Access Compliance Report Public Rights-of-Way (Pedestrian Signals)

Main Street: **ESENCIA_DR** Cross Street: **CHIQUITA_CANYON_DR** Location: **NE**

ADA ID: **SGRK211124134058** Signal Type: **One Push Button-Non APS** Overall Compliance: **No** Severity Scores: **BTN 1: 35** **BTN 2: N/A** **No BTN: N/A**

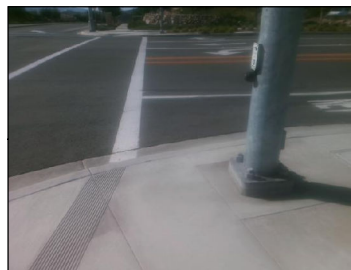
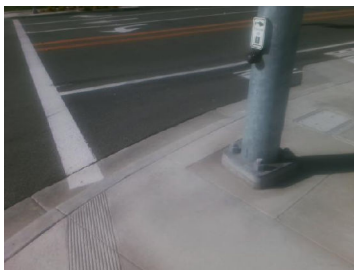
OC Std/PROW: **R404.2, R404.3, MUTCD 4e.08**

Possible Solutions: Replace Signal Push Button With APS Button. Remove and Replace Clear Space.
